DEFENSE LOGISTICS AGENCY
 DLA LAND AND MARITIME
 P.O. BOX 3990
 COLUMBUS, OH 43218-3990

Re: The derating curve of MIL-PRF-39007 and -39009.

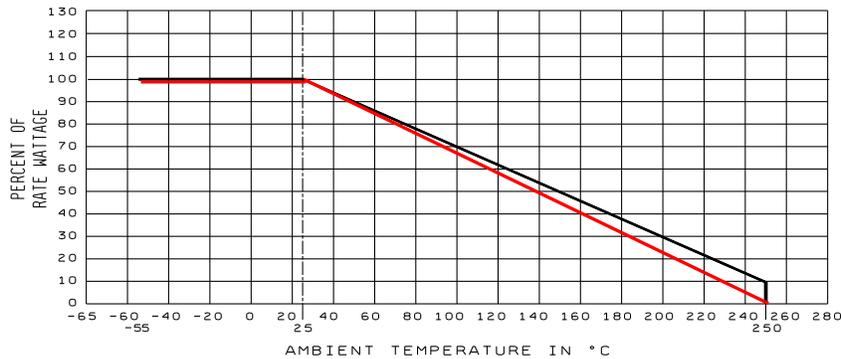
During the last two G-11 committee meeting (May & September 2014) it has been brought up that DLA has received a request to change the present derating curve (figure 1 of MIL-PRF-39007 and -39009) shown in black below to a new derating curve shown in red. The committee asked DLA to send out a survey with some history and justification on why the curve needs to change.

The present derating curve (in black) was changed in December 93 - MIL-PRF-39007G - amd 2, and January 94 - MIL-PRF-39009C - amd 1 from 100% rated wattage at 25°C to 0% at 275°C. Vishay Dale had requested the change in the derating curve to the new proposed curve (in red); this was due to a material change that could not meet the 275°C temperature. A survey of military and industry was taken regarding this request. The survey resulted that the change to 0 percent power at ambient temperature of 250°C was fine, but there were concerns that some circuits would exceed the new curve mid-level power rating, and there would be a cost for the user in reworking their calculation for the middle ranges. As a result it was agree that the curve would drop at the 10 percent power to 0 percent power at 250°C.

The Aerospace Corporation, Ms. Siplon requested changing the curve so the end point of the curve would be 0% power at 250°C. The rationale for this request is because the MIL spec high temperature exposure test at 250°C is run at zero power. No data is being generated to show that the parts will withstand 10% of rated power at 250°C as reflected in the black line of the derating curve above. Designers can mistakenly assume a part capability that is unsupported by test data. Vishay Dale was approach on this change to which they agreed.

Would this change affect your designs today? Would you support this change?
